## Planning Commission Staff Report

**MEETING DATE:** FEBRUARY 5, 2014

**SUBJECT:** Z13-12: REQUEST TO AMEND ORDINANCE NOS. 1597 AND 1956 AND REZONE APPROXIMATELY 17.5 ACRES OF REAL PROPERTY WITHIN THE COPPER RANCH PLANNED AREA DEVELOPMENT (PAD), GENERALLY LOCATED SOUTH AND EAST OF THE SOUTHEAST CORNER OF WARNER AND RECKER ROADS FROM MULTI FAMILY-MEDIUM (MF-M) ZONING DISTRICT WITH A PLANNED AREA DEVELOPMENT (PAD) OVERLAY TO SINGLE FAMILY-DETACHED (SF-D) ZONING DISTRICT WITH A PLANNED AREA DEVELOPMENT (PAD) OVERLAY.

Copper Ranch  
Gilbert, Arizona  
Parking Exhibit

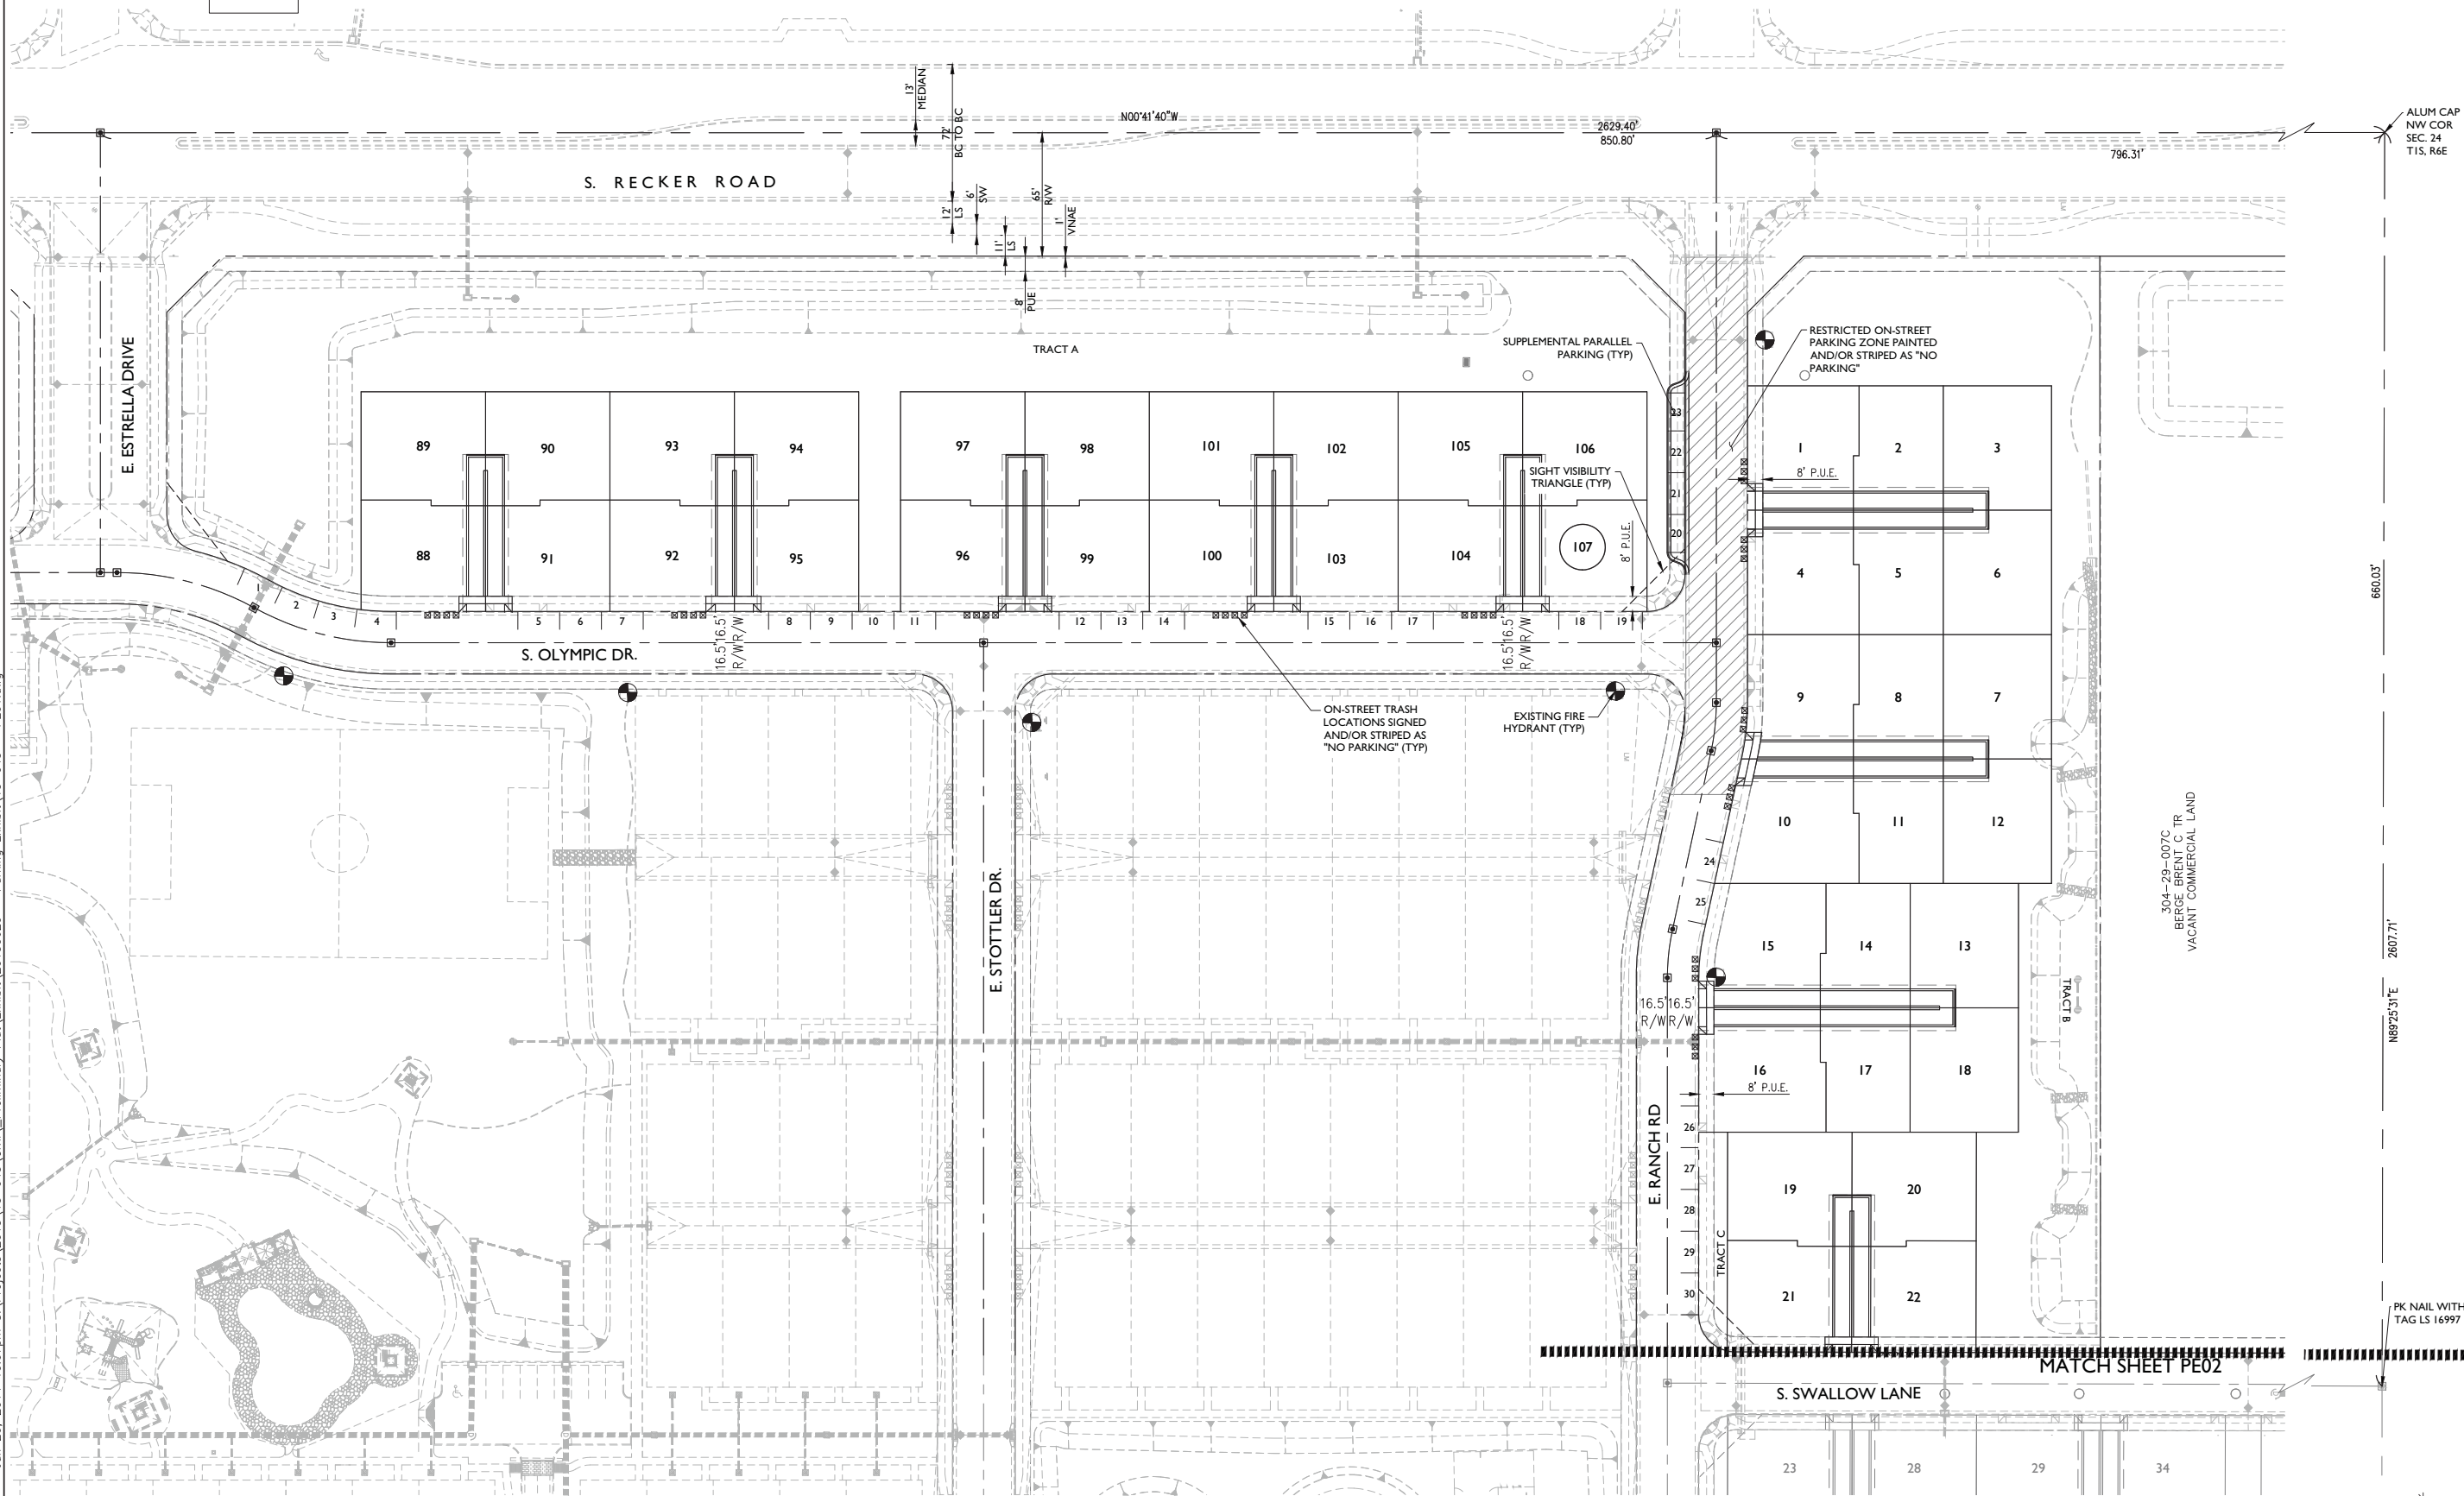
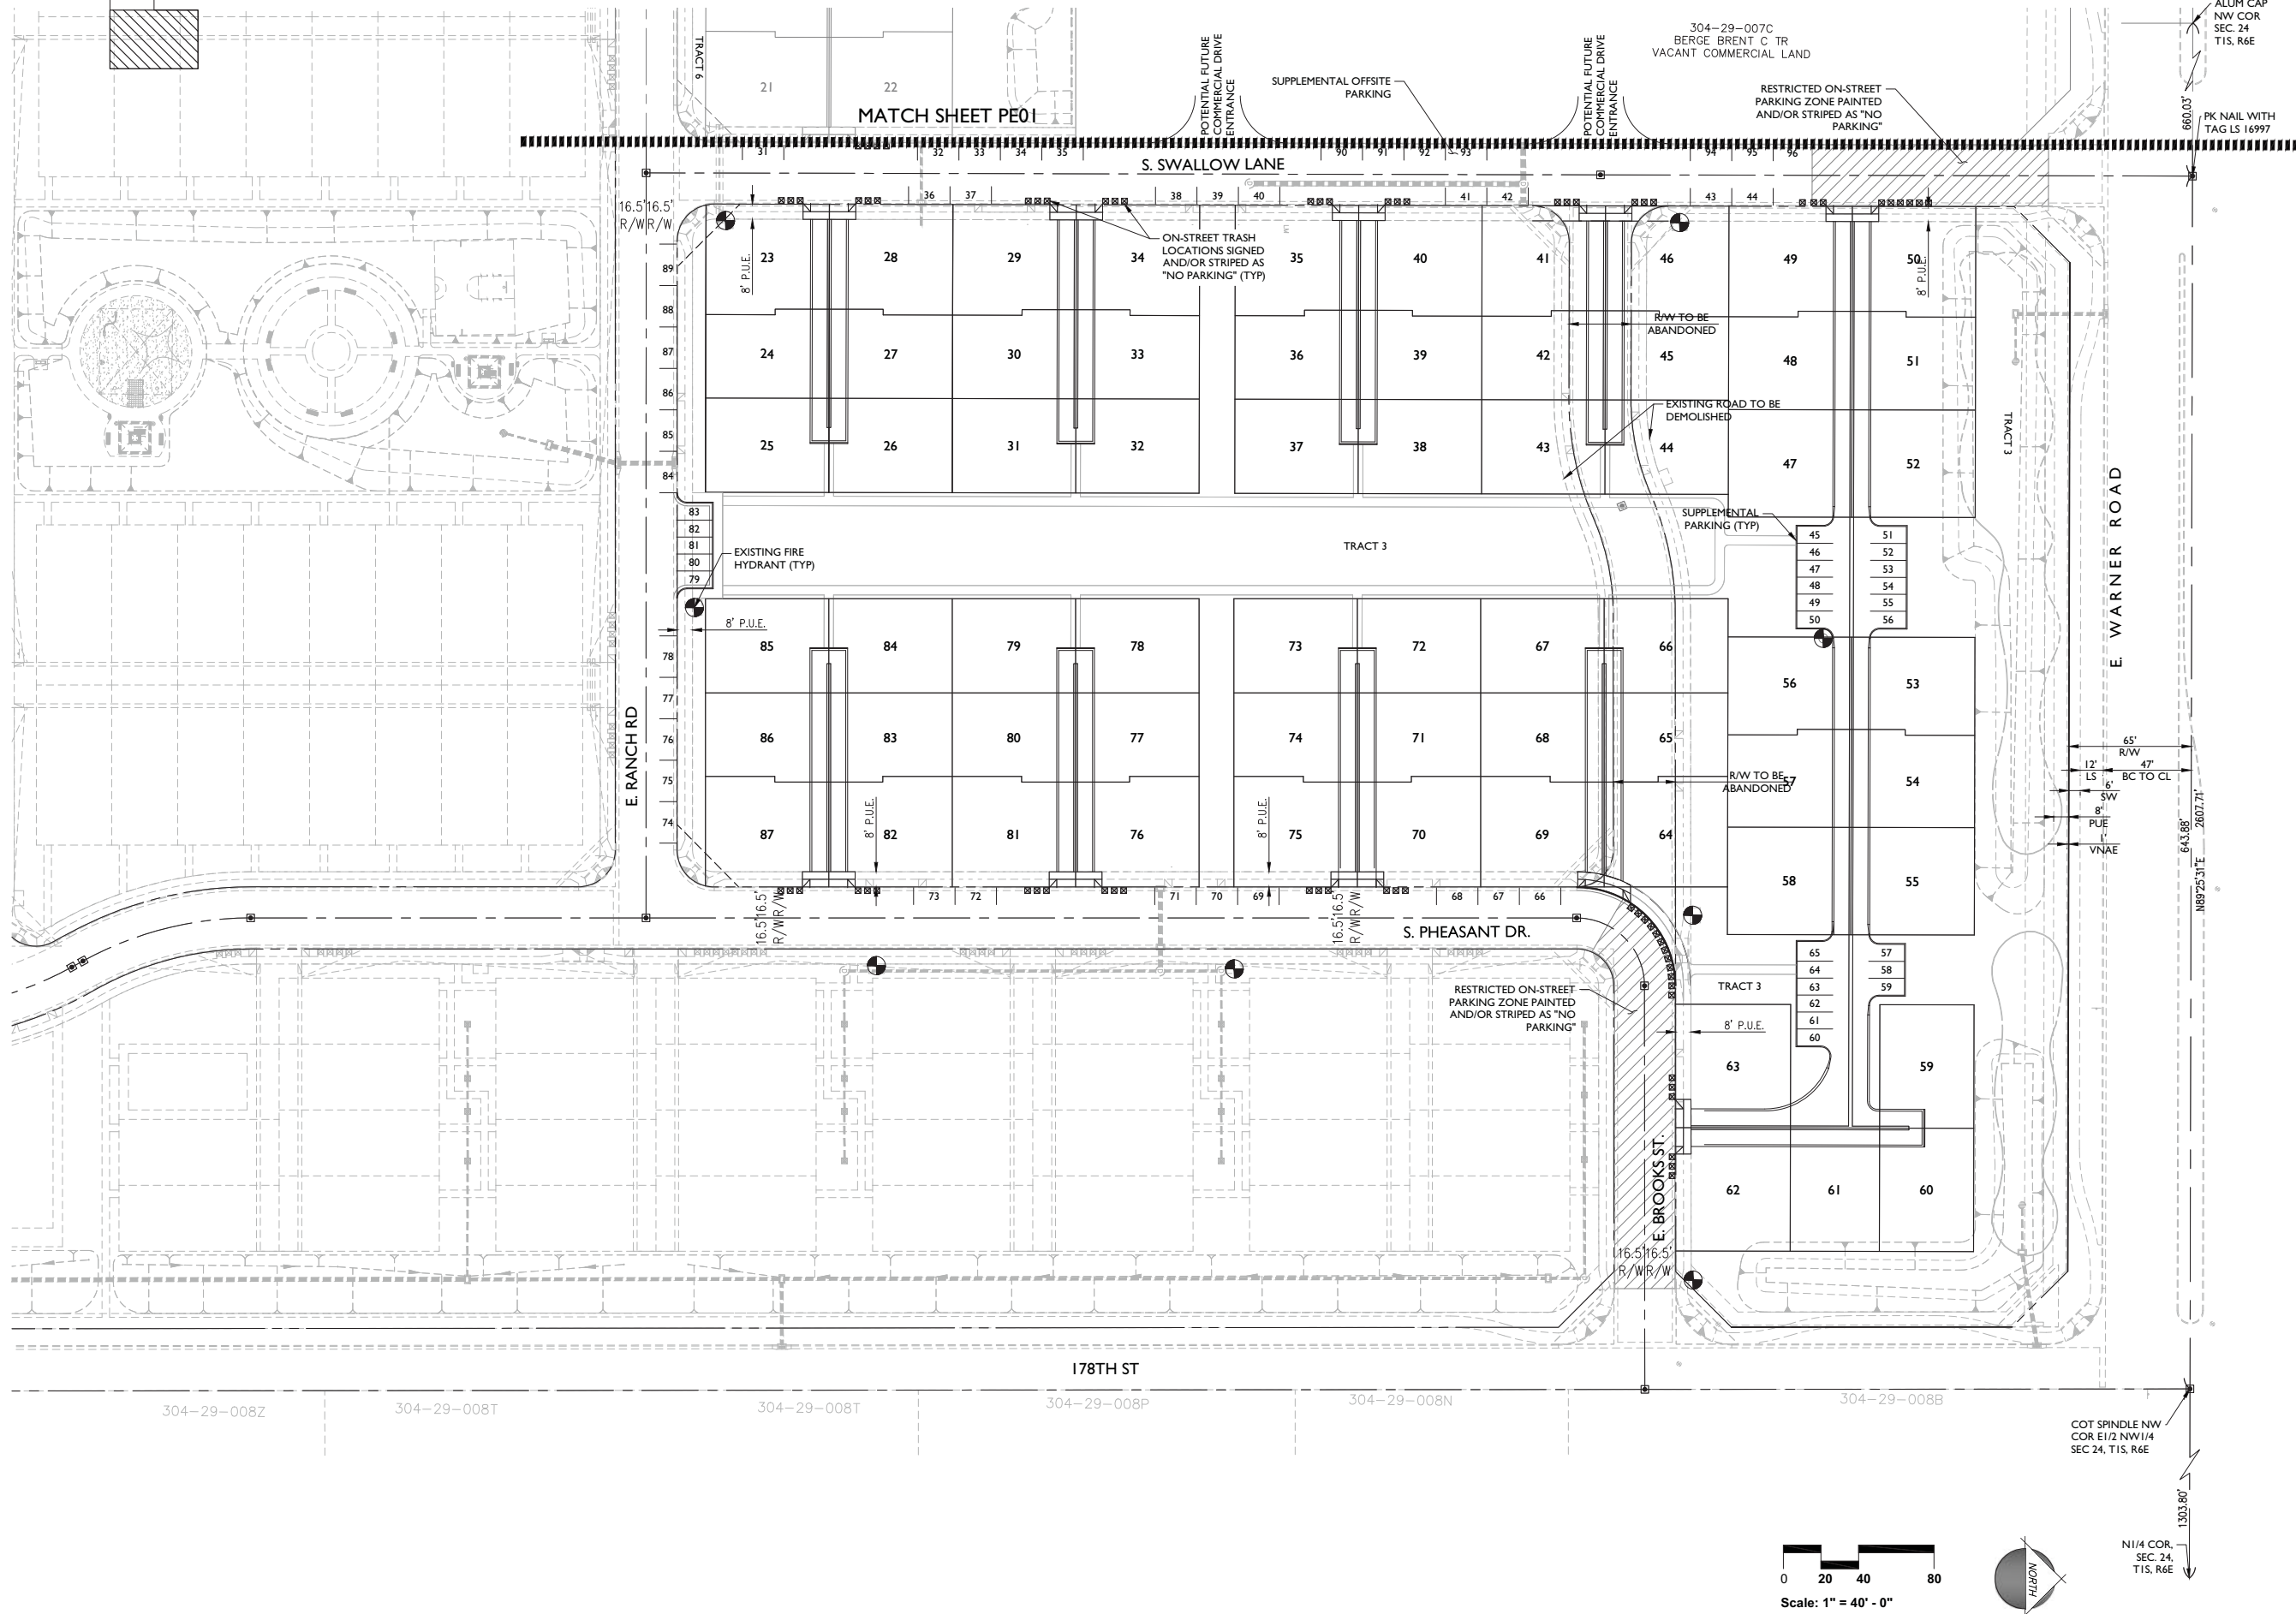
Since July, the applicant has produced several iterations of the Development Plan and parking exhibits to respond to the Planning Commission concerns and to the Traffic and Sanitation requirements regarding the functionality of the project. Because the proposed street design allows for on-street parking, there is not a requirement for guest parking per LDC Table 4.204. However, to address operational concerns, the applicant revised the parking exhibits and now offers 30 off-

street parking spaces in four (4) separate off-street parking alcoves throughout the project in addition to the designated parallel on-street parking spaces.

- The number of off-street parking stalls illustrated on the parking exhibit per the last submittal shows an increase from 22 to 30 spaces (refer to Traffic evaluation below).

*Traffic/Sanitation Evaluation:* as previously stated by Traffic, the pull-in parking spaces on Ranch Road are not acceptable because for these spaces to work, the on-street parking on the opposite side of this road will have to be removed. Therefore, the overall net gain of off-street parking stalls is only 3 spaces added within the parking pockets to the north between the 5 and 6-pack modules. The illustration of this additional off-street parking should be removed from the exhibits before action by the Town Council. Although Sanitation approved the designated location of the refuse bins along the elbow curb linking Pheasant Drive and Brook Street, Traffic requires relocating them out of the curb and placing them along the straight alignment of Brook Street to avoid an

effective narrowing of the street by 5 feet for the turning traffic. Other specific issue on connectivity from off-street parking stalls to sidewalks should be addressed by the applicant as part of the on-going preliminary plat review.
